1A TELEPHONE ANSWERING SET STATION CONNECTIONS

1.01 This addendum, which supplements Issue 2 of the section and replaces addendum Issue B, provides additional information on connections for the 1A answering set.

Fig. A

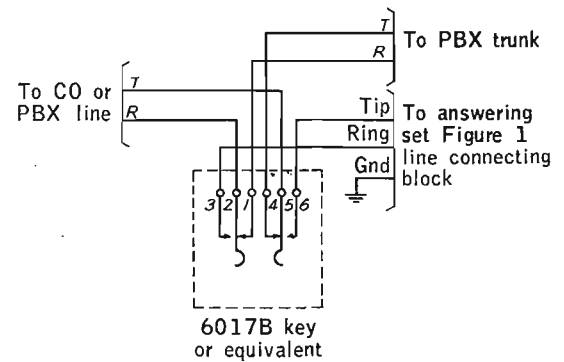
1.04 When the 1A answering set is connected to a PBX trunk circuit, it shall be wired as shown in Figure A.

NOTE: When Figure A is used, the answering set must be equipped with a separate telephone set.
